HISTORIC AND DESIGN REVIEW COMMISSION

HDRC CASE NO: 2022-111
ADDRESS: 515 NOLAN ST
LEGAL DESCRIPTION: NCB 546 BLK 19 LOT E 7 FT OF 13 & W 46.5 FT OF 14
ZONING: R-6, H
CITY COUNCIL DIST.: 2
DISTRICT: Dignowity Hill Historic District
APPLICANT: Raul Jimenez
OWNER: Sergio Medellin/515 NOLAN ST SERIES
TYPE OF WORK: Amendment to a previously approved rear addition, roof modifications
APPLICATION RECEIVED: February 10, 2022
60-DAY REVIEW: Not applicable due to City Council Emergency Orders
CASE MANAGER: Edward Hall

The applicant is requesting a Certificate of Appropriateness for approval to amend the previously approved design for a rear addition regarding roof profile and ridge height.

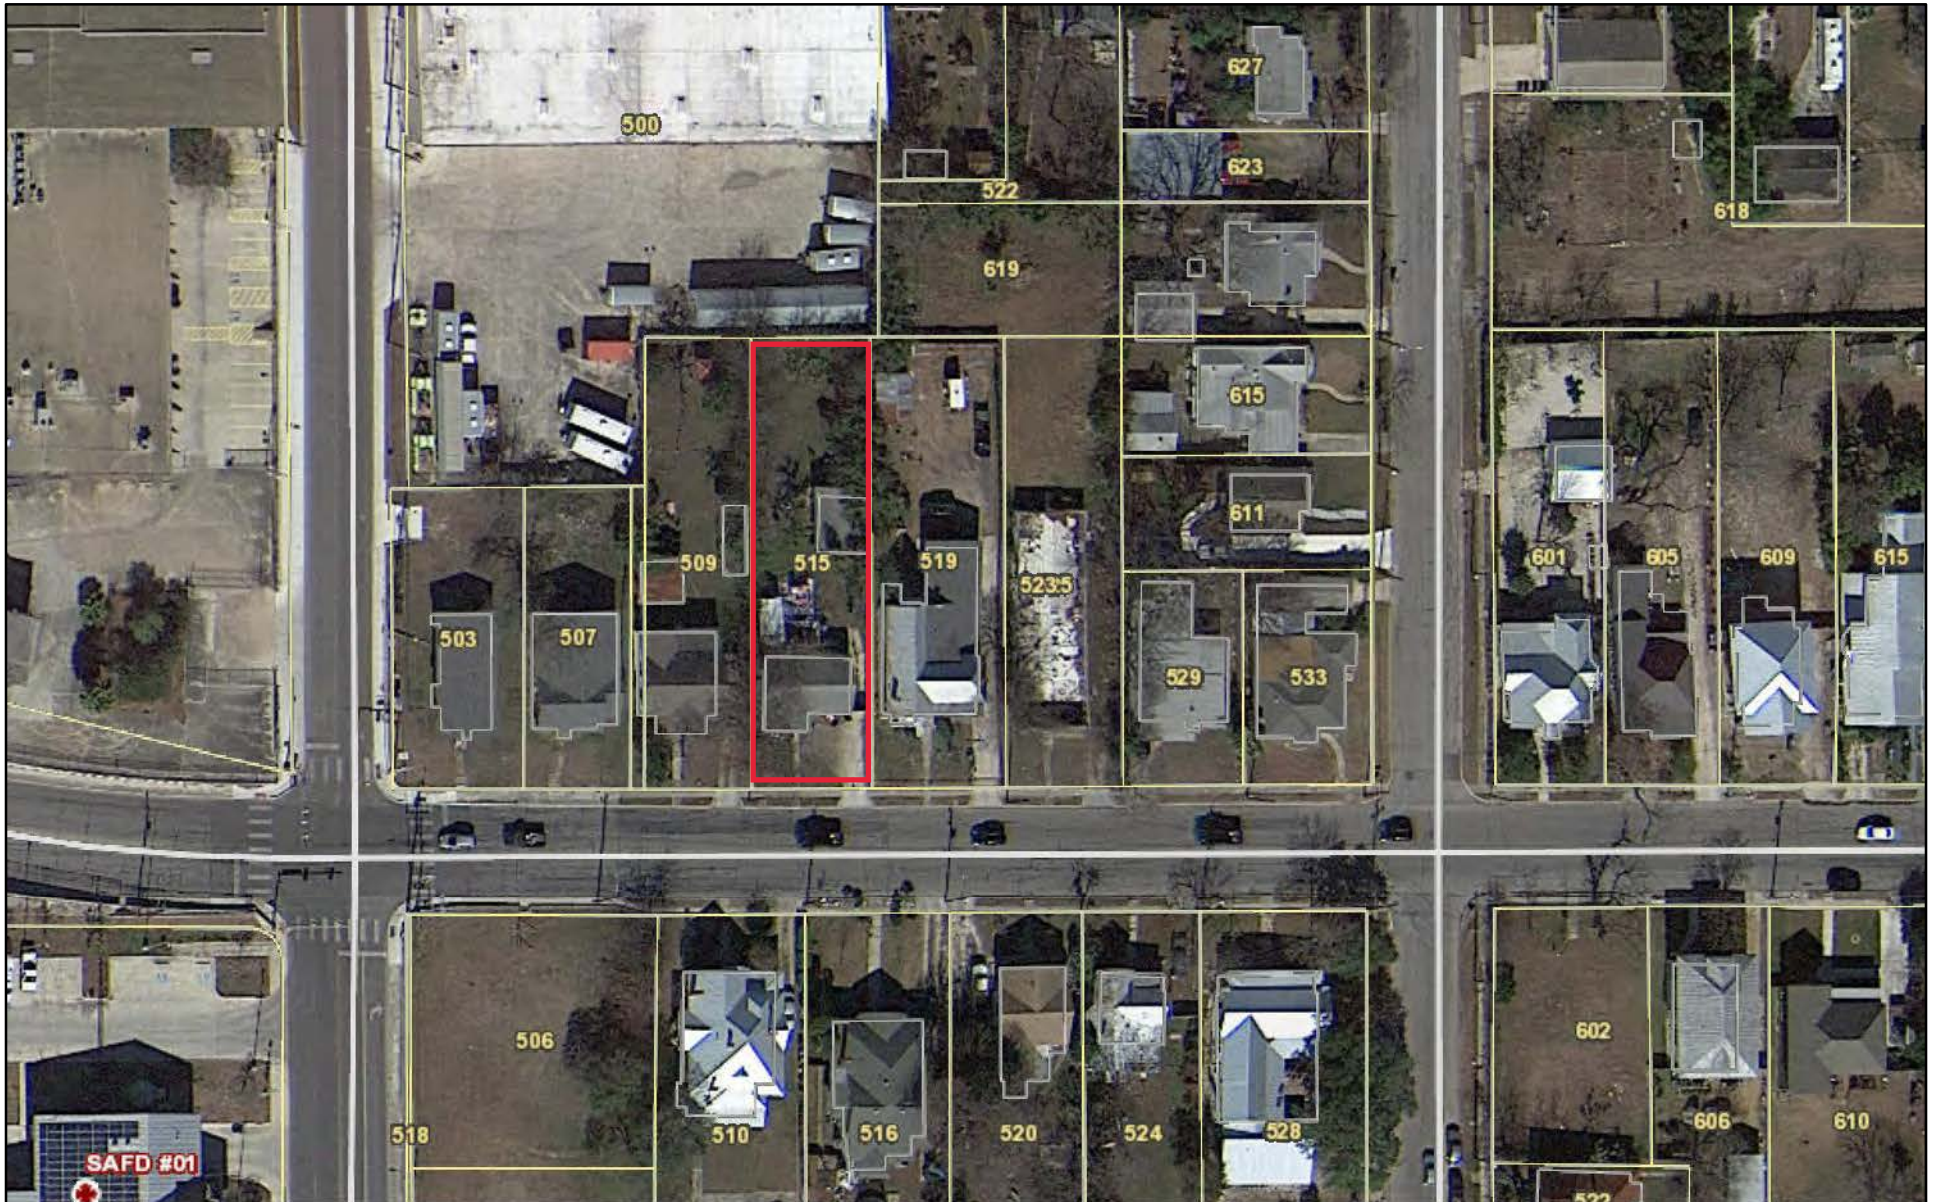
A Certificate of Appropriateness and permits were issued prior to the stipulations of the approved design being met. The applicant began construction and has continued to perform work per the permitted construction documents.

- c. **AMENDMENT** – An approval from the Historic and Design Review Commission is needed for the permitted and constructed design. Generally, staff finds the proposed design to be appropriate. The overall massing and profile is consistent with those found historically within the district.
- d. **AMENDMENT** – The applicant has previously coordinated siding installation with OHP staff. At the time of final approval, the applicant proposed to install a vinyl window, which was not consistent with staff's standards for windows in new construction. Staff finds that windows that are consistent with staff's standards for windows in new construction should be installed.

Staff recommends approval based on findings a through d with the following stipulation:

- i. That windows that are consistent with staff's standards for windows in new construction be installed.
